Safety Recall H0H (Interim H1H) – *Interim Notice*
Certain 2016-2017 Model Year Tacoma
Crankshaft Position Sensor

Frequently Asked Questions
Original Publication Date: June 1, 2017

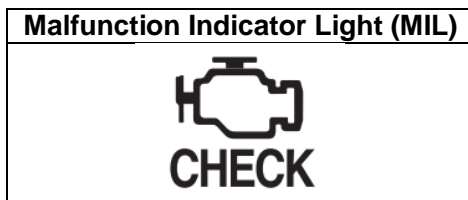
A1: The V6 engine crankshaft timing rotor in the involved vehicles may have been produced with excessive anti-corrosion coating. This could cause the crankshaft position sensor to malfunction. If this occurs, the vehicle may display a Malfunction Indicator Light (MIL), run roughly, misfire, or in some instances, stall. A stalling condition while driving at higher speeds may increase the risk of a crash.

A2: Toyota is currently preparing the remedy for this condition. When the remedy becomes available, Toyota will send an owner notification by first class mail starting in mid-July, 2017, advising owners to make an appointment with their authorized Toyota dealer to have the crankshaft position sensor replaced with a new one of an improved design at **NO CHARGE**.
